### APPEAL SUMMARY

**Appeal ID:** 19041

**Project Address:** 631 SE Taylor St

**Building/Business Name:** The Rose Apartments

ADDITIONAL APPEAL  
SKETCHES

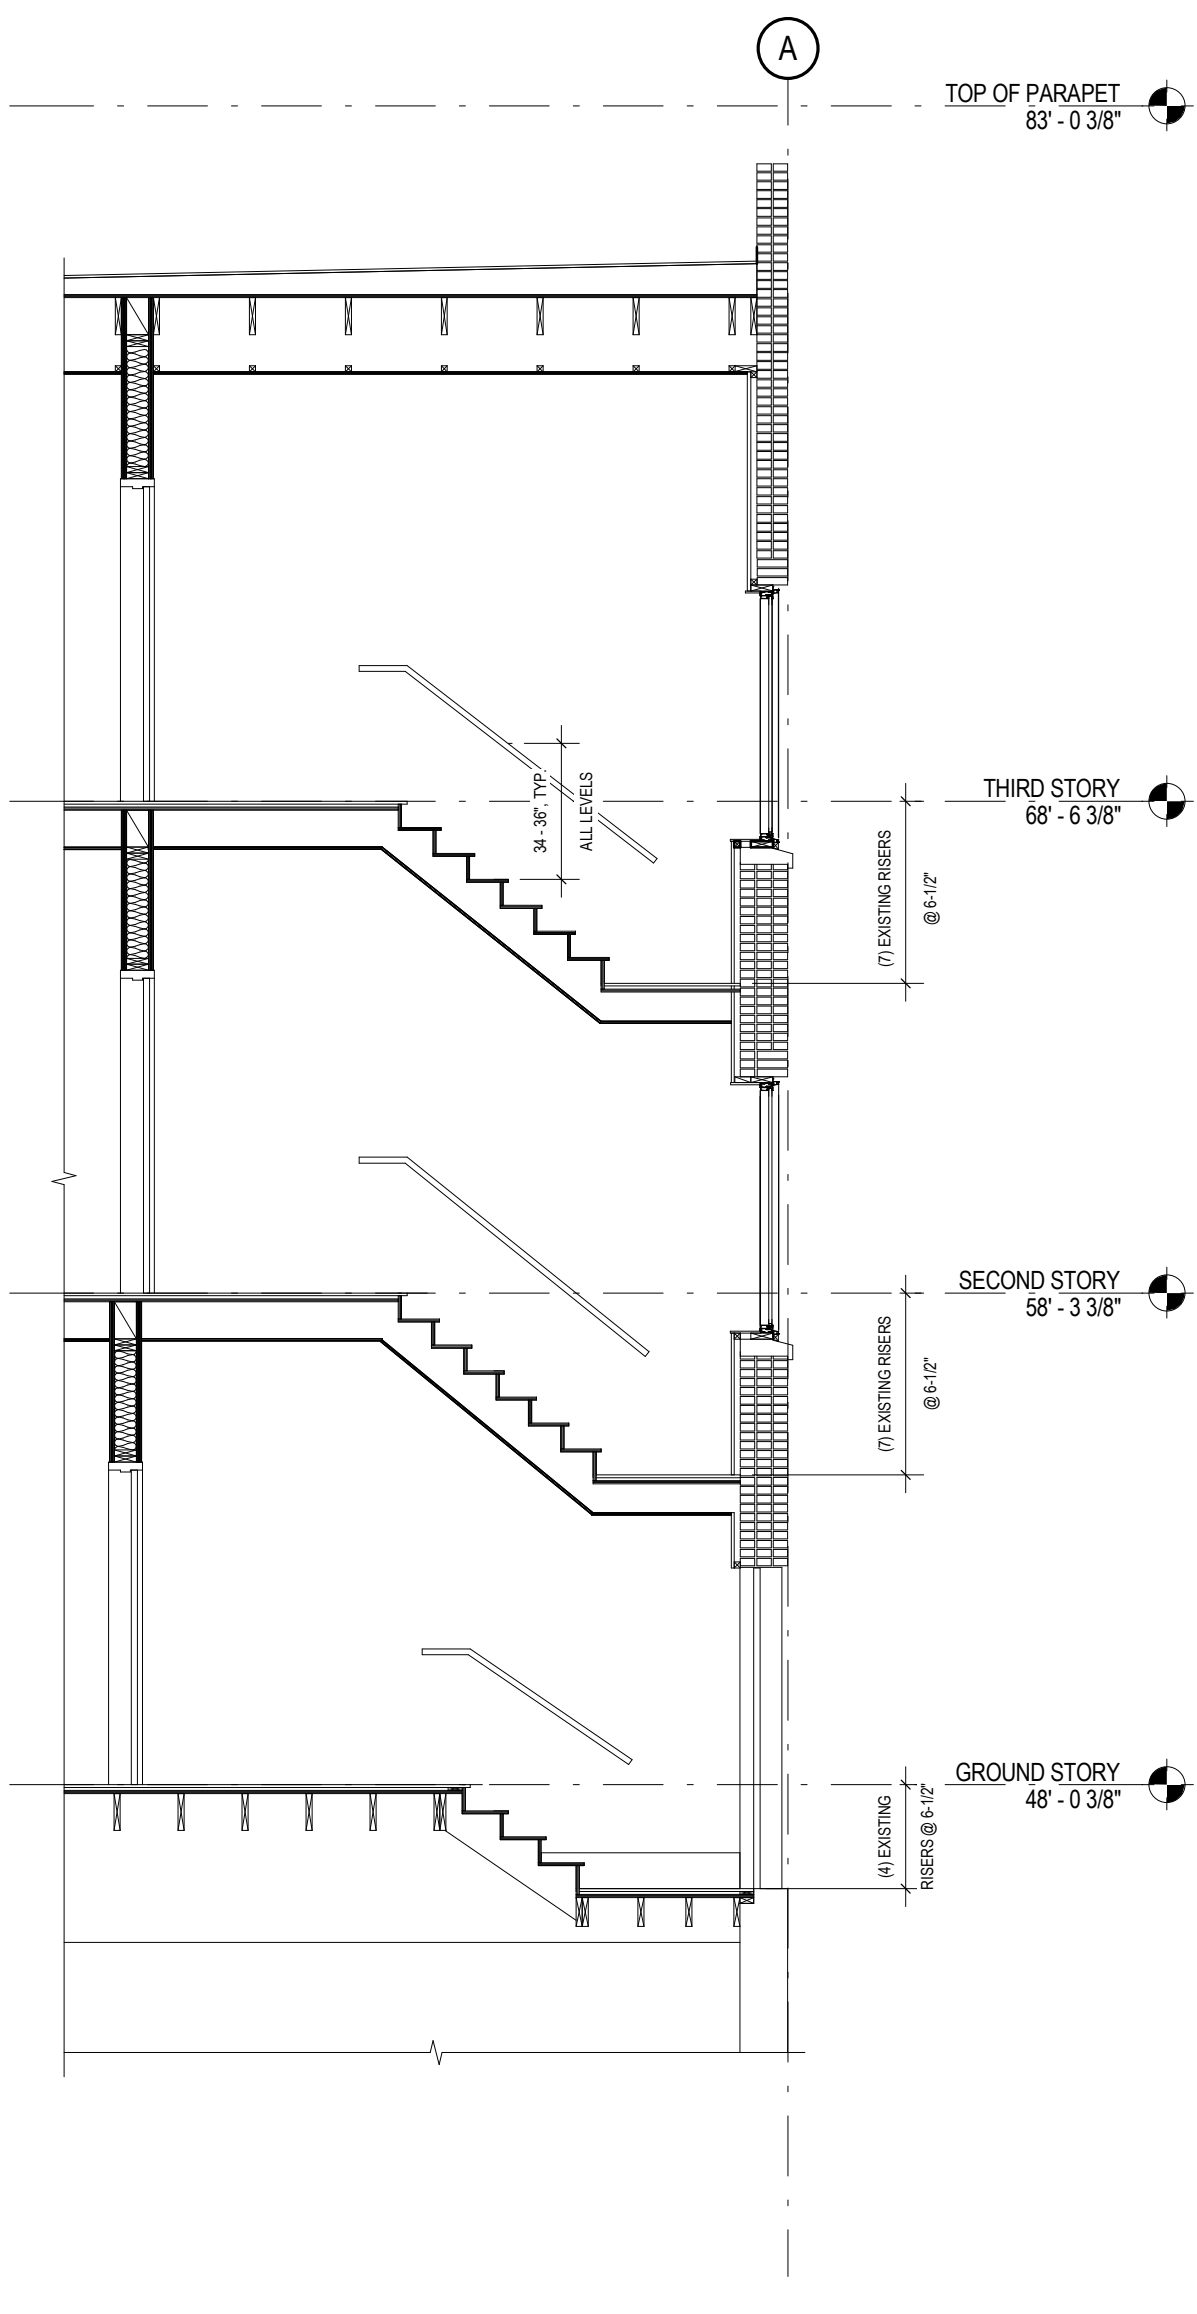
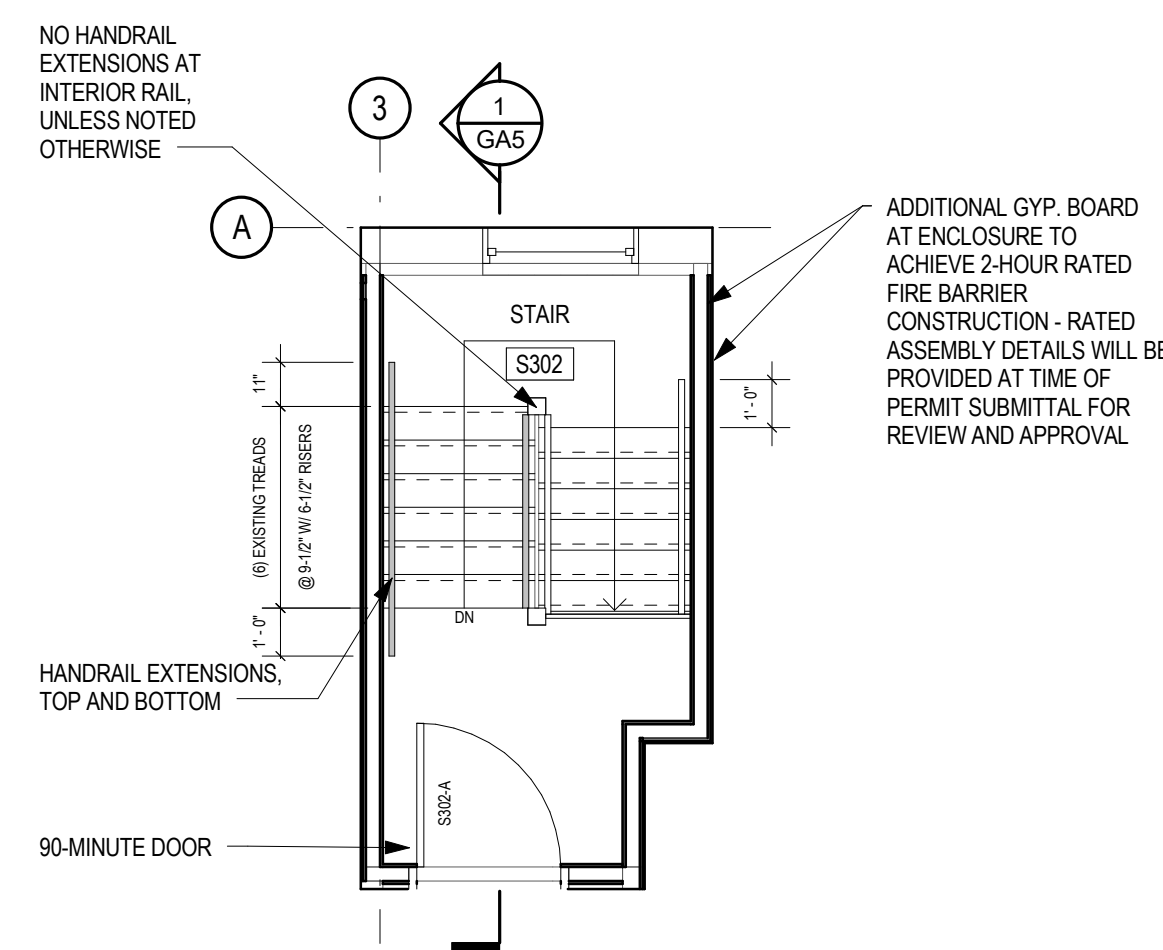
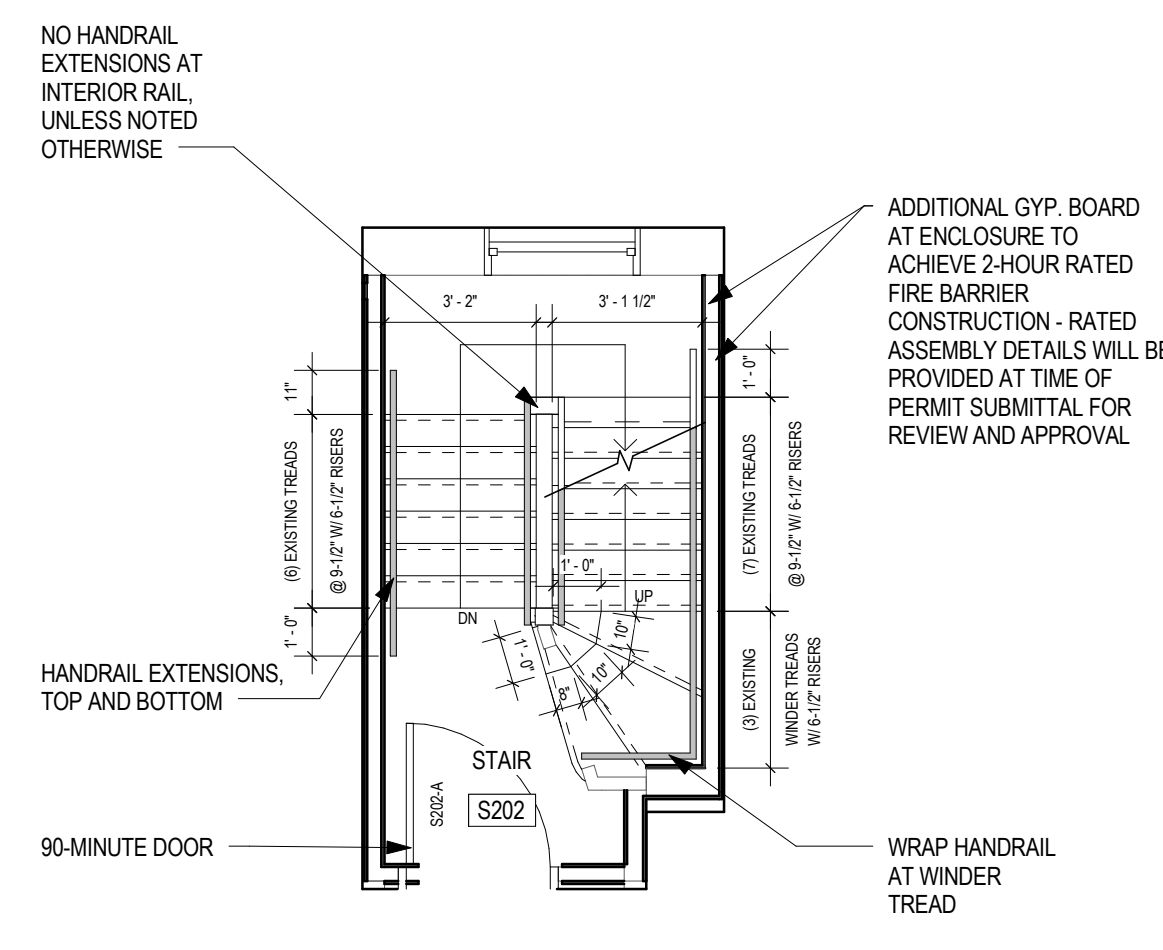
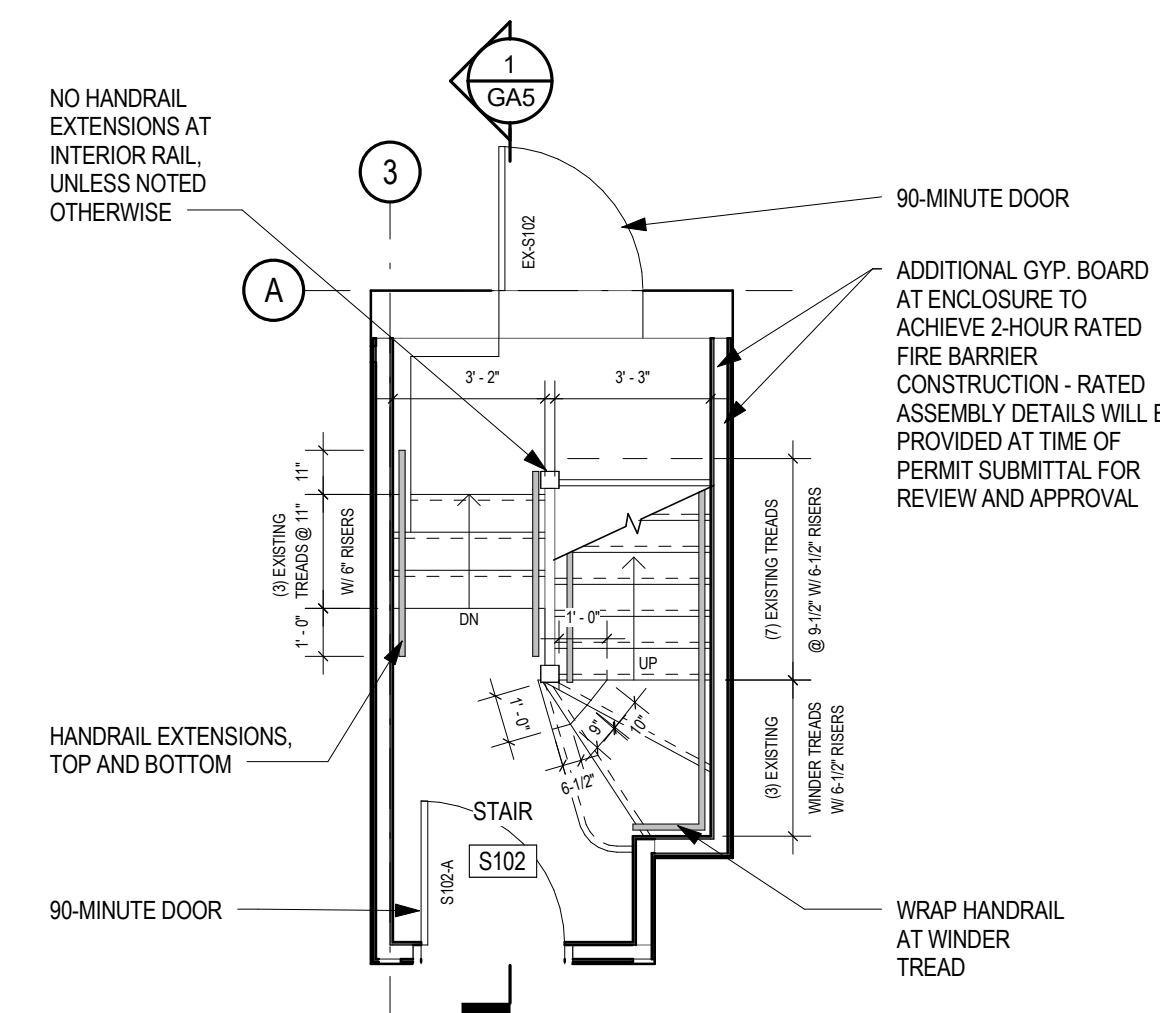
<b>Code Section</b>	1009.7.3 Winder Treads
<b>Requires</b>	Winder treads are not permitted in means of egress stairways except within a dwelling unit.
<b>Proposed Design</b>	<p>ORIGINAL APPEAL TEXT: The existing winder treads in northeast and northwest stairs will remain. These have been approved by previous appeals dated 8/8/74 and 1/27/88. The exit stair enclosures will be repaired to achieve the required 1- and 2-hour construction. New rated doors will be provided. New lighting to meet the requirements of Section 1006 will also be provided within the stair enclosures. See Details 2, 3, 5 and 8/GA4.</p> <p>RECONSIDERATION TEXT: The existing winder treads in northeast and northwest stairs will remain. These have been approved by previous appeals dated 8/8/74 and 1/27/88. The exit stair enclosures will be repaired to achieve the required 1- and 2-hour construction. New rated doors into the enclosures and to the Egress Court will be provided. New lighting to meet the requirements of Section 1006 will be provided within the stair enclosures. A sufficient landing inside the basement enclosure door will be provided in Stair S001, where there is no landing currently. An existing noncompliant opening into Stair S101 will be removed and filled in with 2-hour fire barrier construction. Handrails complying with height requirements of 1012.2 will be provided on either side where there are only handrails on one side currently (refer also to Appeal Item #4 – Handrail Extensions).</p> <p>See Details 2, 3, 5 and 8/GA4, and Details 1, 2, 3 and 5/GA5.</p>

<b>Code Section</b>	1012.6 Handrail Extensions
<b>Requires</b>	Where handrails are not continuous between flights, the handrails shall extend horizontally at least 12 inches beyond the top riser and continue to slope for the depth of one tread beyond the bottom riser.
<b>Proposed Design</b>	<p>ORIGINAL APPEAL TEXT: Within the existing northeast and northwest exit stairs, compliant top and bottom rail extensions will be provided where the plan configuration allows. Where there is not room for extensions due to existing conditions and space constraints, extensions will not be provided. See Details 2, 3, 5 and 8/GA4 for more detailed information.</p> <p>RECONSIDERATION TEXT: Within the existing northeast and northwest exit stairs, compliant top and bottom rail extensions will be provided where the plan configuration allows. Handrails will wrap the wall at winder tread locations. Where there is not room for extensions due to existing conditions and space constraints, extensions will be provided to the maximum length possible. See Details 2, 3, 5 and 8/GA4 and 1, 2, 3, 4 and 5/GA5 for more detailed information.</p>

**2. Winder treads in 2 egress stairs: Granted as proposed.**

**3. Omission of handrail extensions in 2 egress stairs: Granted as proposed.**
